INSPECTOR GENERAL

JULY 18, 2013

Compliance with Electrical and Fire Protection Standards of U.S. Controlled and Occupied Facilities in Afghanistan

Figure 1. Reverse Polarity and No Grounding - Chaplain's Office Building Kitchen Area

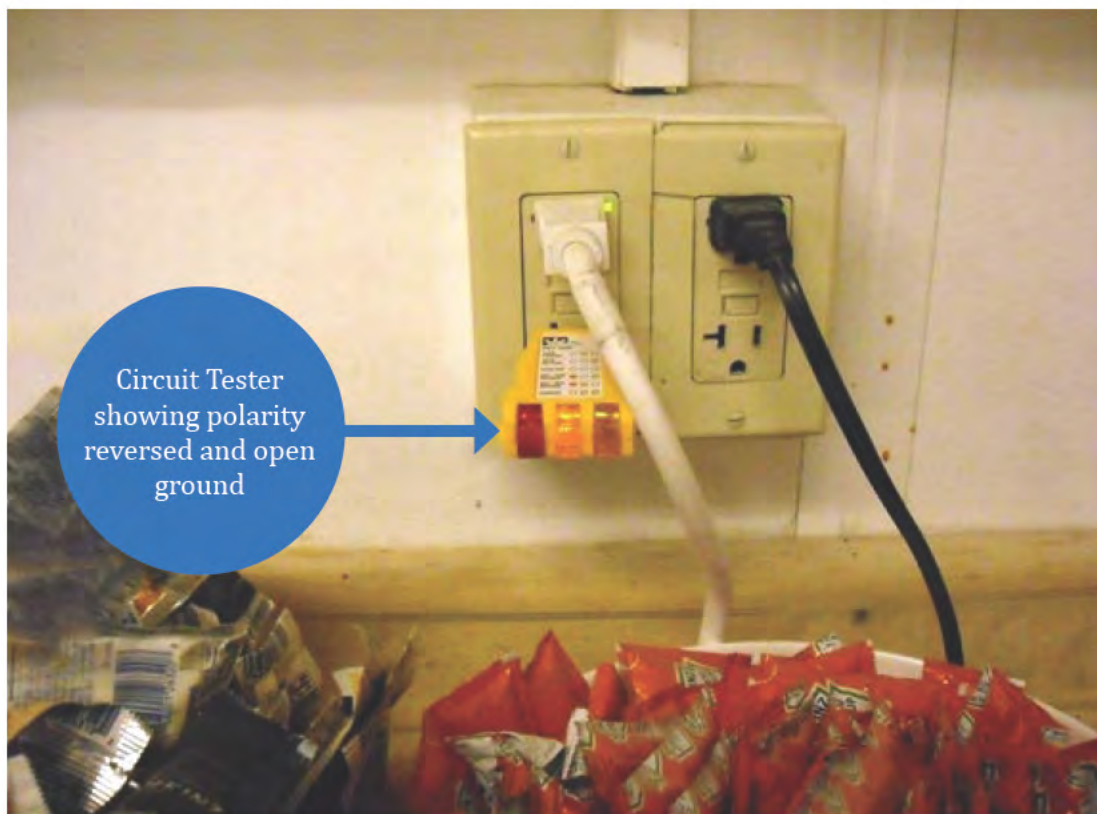
1. **Grounding and bonding:** No bonding between neutral and grounding bus bars in main panels, many cases of exposed grounding conductors and electrodes unprotected from damage, missing ground prongs, and missing and incorrectly wired Ground Fault Circuit Interrupter (GFCI) receptacles (Figure 1). The missing ground contact does not provide a return path for the ground fault current. A ground fault could energize the metal on any device plugged into extension cords without tripping the circuit breaker. Metal surfaces on appliances can also become energized without tripping the circuit breaker. These grounding issues could lead to fire, electrical shock, and/or electrocution.

KAF-EL-120426-075
Figure 6. Hazardous Workmanship

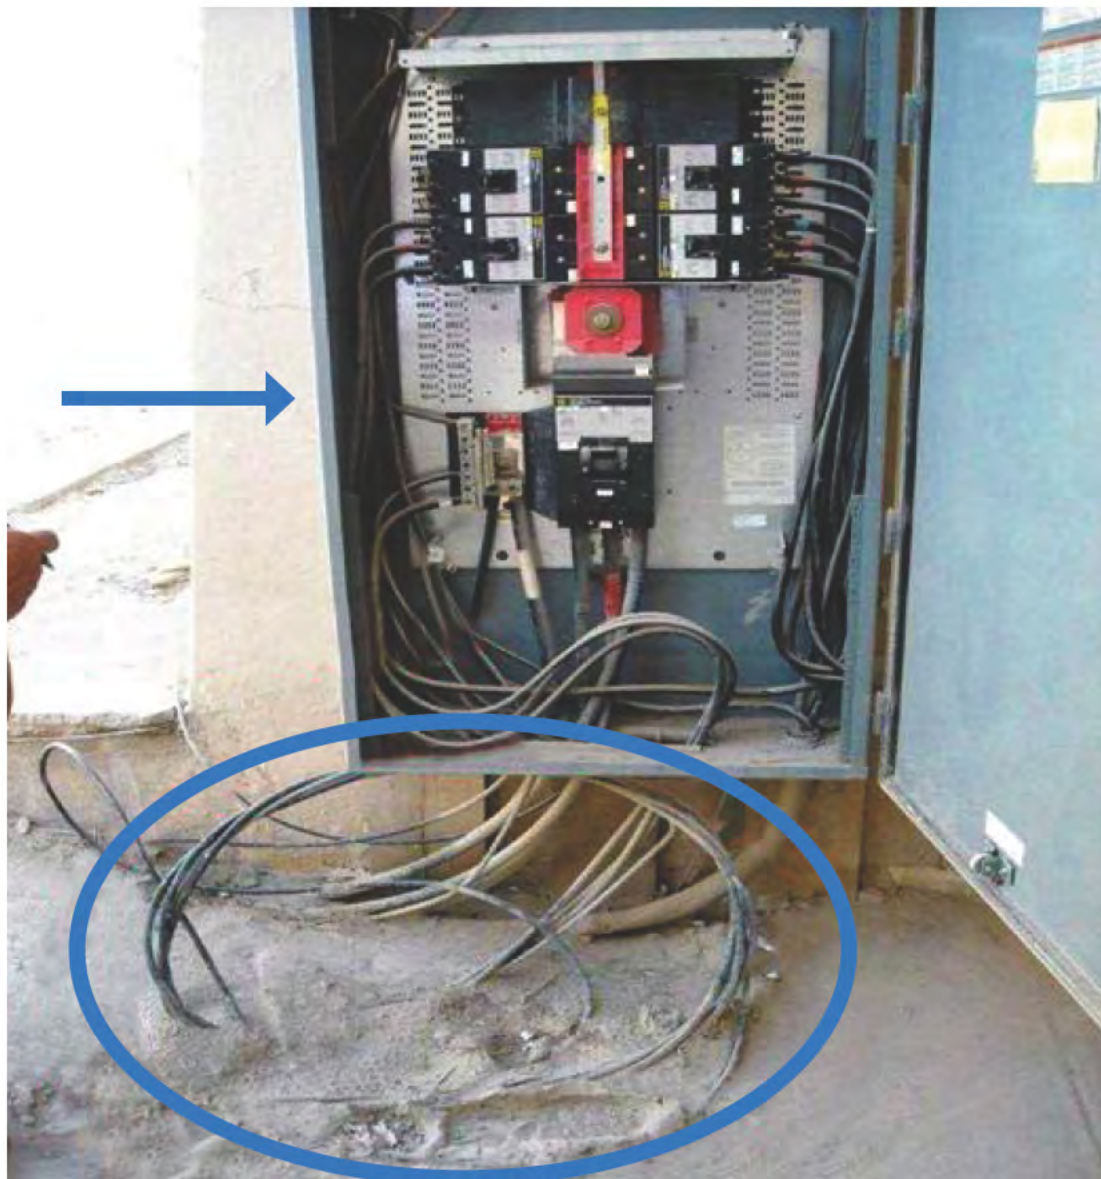
was significant. Extension cords used under these conditions are subject to damage and abrasion (figure 5). The use of an extension cord instead of fixed wiring creates the possibility of fire, electrical shock, and/or electrocution due to unprotected live conductors and overloading of circuitry.

Figure 12. Nonfunctional Kitchen Fume Hood Fire Suppression Systems
(Note Flammable Grease in Light Fixture)

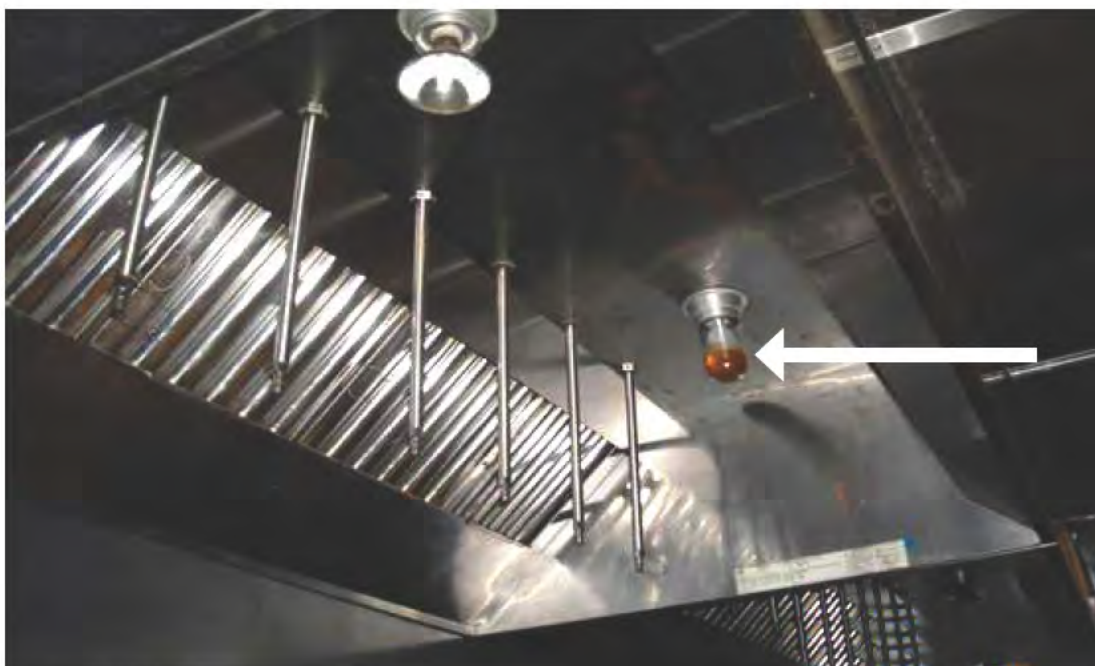
2. **Fire suppression:** Lack of sprinkler systems, and fire sprinkler pump houses that are nonfunctional or not maintained. This is significant as fire sprinklers are the most effective means of controlling a fire in the incipient stages and reducing the risk of injury or loss of life. Also includes kitchen hood extinguishers that are nonfunctional or not maintained (Figure 12). Kitchens have deep fryers and cooking equipment that produce grease-laden vapors. Failure to maintain a functional fire suppression system for kitchen cooking equipment results in an increased risk of fire and a significant risk of fire spreading rapidly throughout the facility.
